- 8. Wahl Subdivision; KPB File 2022-092R1
Segesser Surveys / Whal
Location: Adele Avenue & Montgomery Avenue
Sterling Area**

Wahl Subdivision

KPB File No.	2022-092R1
Plat Committee Meeting:	September 26, 2022
Applicant / Owner:	Beverly A Wahl of Sterling, AK
Surveyor:	John Segesser / Segesser Surveys
General Location:	Adele Avenue, Robinson Loop Road, Montgomery Avenue, Sterling

STAFF REPORT

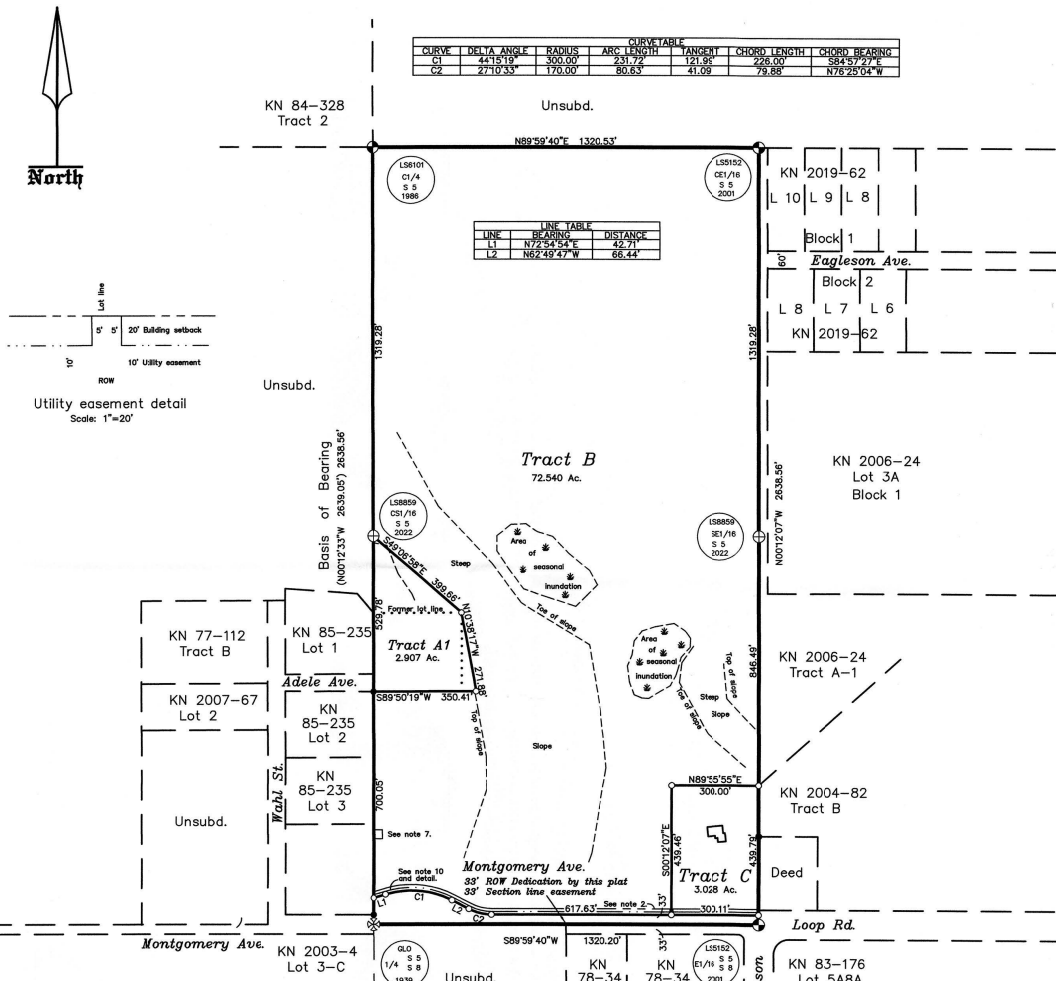
- On the drawing, reference to note 7, should be 9.
- The utility easement detail should be reviewed as the depiction appears to be missing information or not labeled correctly.

- Staff recommendation:** Revise legal to include Tract A, add R1 to end of the KPB number.
- C. The location, width, and name of existing or platted streets and public ways, railroad rights-of-way, and other important features such as section lines or political subdivisions or municipal corporation boundaries abutting the subdivision;

- Staff recommendation:** Add ROW width to Adele Avenue, Montgomery Avenue to the west, Robinson Loop Rd to the east. Depict and label the adjacent section line easements where dedications have not been granted.

- Staff recommendation:** Include Tract A in the darkened area.
- E. All parcels of land including those intended for private ownership and those to be dedicated for public use or reserved in the deeds for the use of all property owners in the proposed subdivision, together with the purposes, conditions, or limitations of reservations that could affect the subdivision;

- Staff recommendation:** It should be determined by the surveyor with further research of the document in book 273 page 486 the location of the access. Document mentions a tax map that is not included in the Certificate to Plat or attached with the document on the recorders website.

- Staff recommendation:** Provide an additional dedication label for the wider portion of Montgomery Avenue as that portion is not 33 feet in width.
- G. The status of adjacent lands within 100 feet of the proposed subdivision boundary or the land status across from any dedicated rights-of-way that adjoin the propose subdivision boundary, including names of subdivisions, lot lines, block numbers, lot numbers, rights-of-way; or an indication that the adjacent land is not subdivided;

Staff recommendation: Parcel in southwest corner from plat needs label. Parcel to the east of plat needs correct plat reference

Staff recommendation: On Montgomery Homestead KRD76-46 is shown a 20 foot building setback line going around the temp turn around.

Staff recommendation: Add a wastewater disposal note for Tract A1. Comply with 20.40.

Staff recommendation: make the lines for Tracts A1 and Tract C lighter

Wahl Subdivision

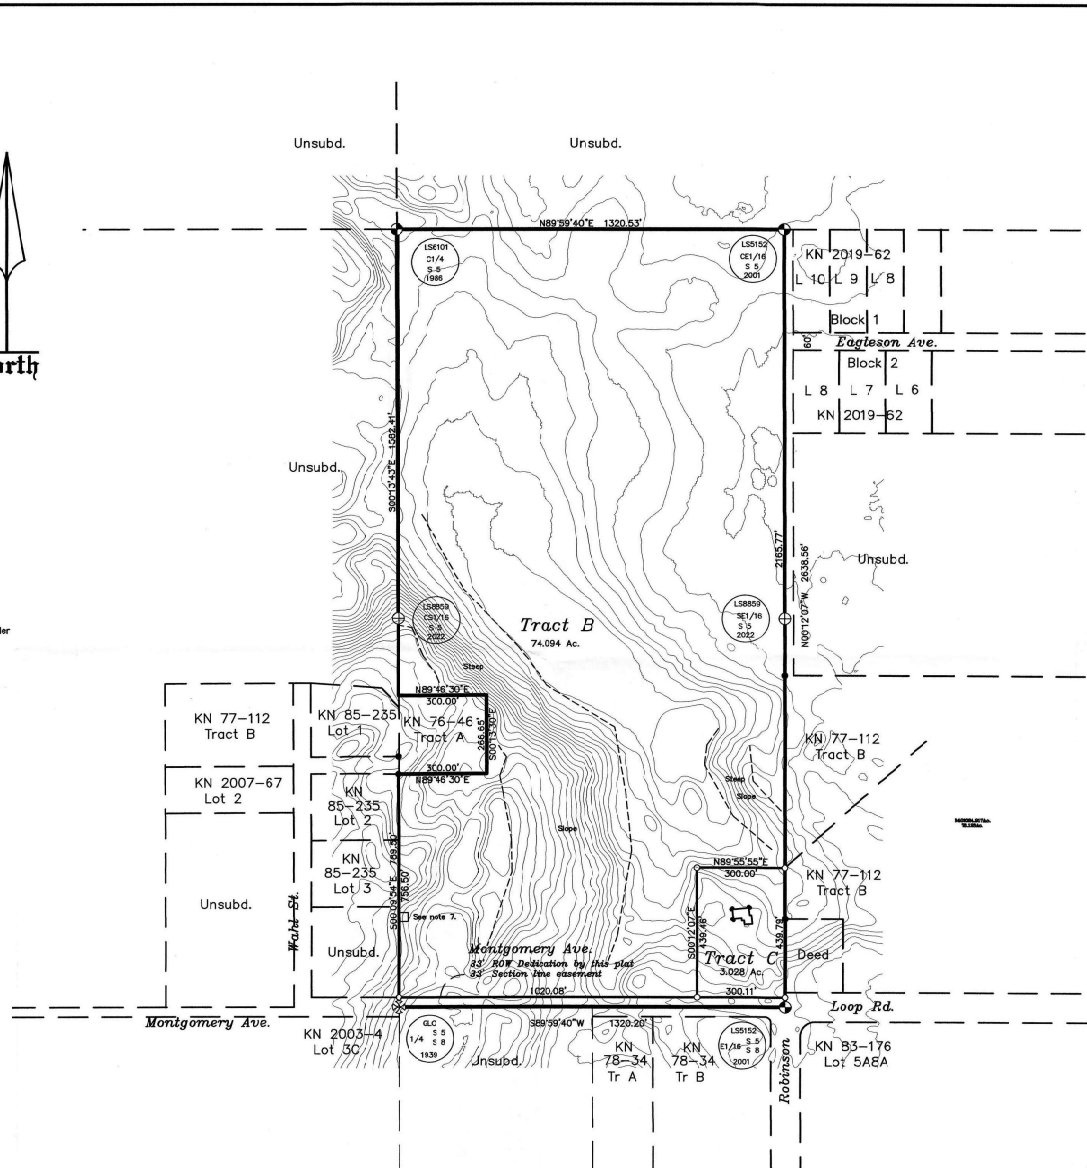
- Any rights-of-way being shown should include a width label.
 - There is an overstrike on the Wahl Street label.
 - Provide a street name label for Adele Avenue in addition to a width label.

- The southern Tract B to the east is from KN 2004-82 and miscellaneous text appears within the lot boundary.
 - Lot 3C to the southwest is Lot 3-C.
 - On the vicinity map, place the site in the correct location.

- Correct the drawing of KN 85-235 Lot 1 as needed.

- Add a plat note for any exceptions granted.
- Any person developing the property is responsible for obtaining all required local, state, and federal permits, including a U.S. Army Corps of Engineers wetland determination if applicable.

Correct plat note 3 code reference, should be 20.60.170.

Get complete copy of easement referenced in Book 273 Page 486 to correctly show location of easement.
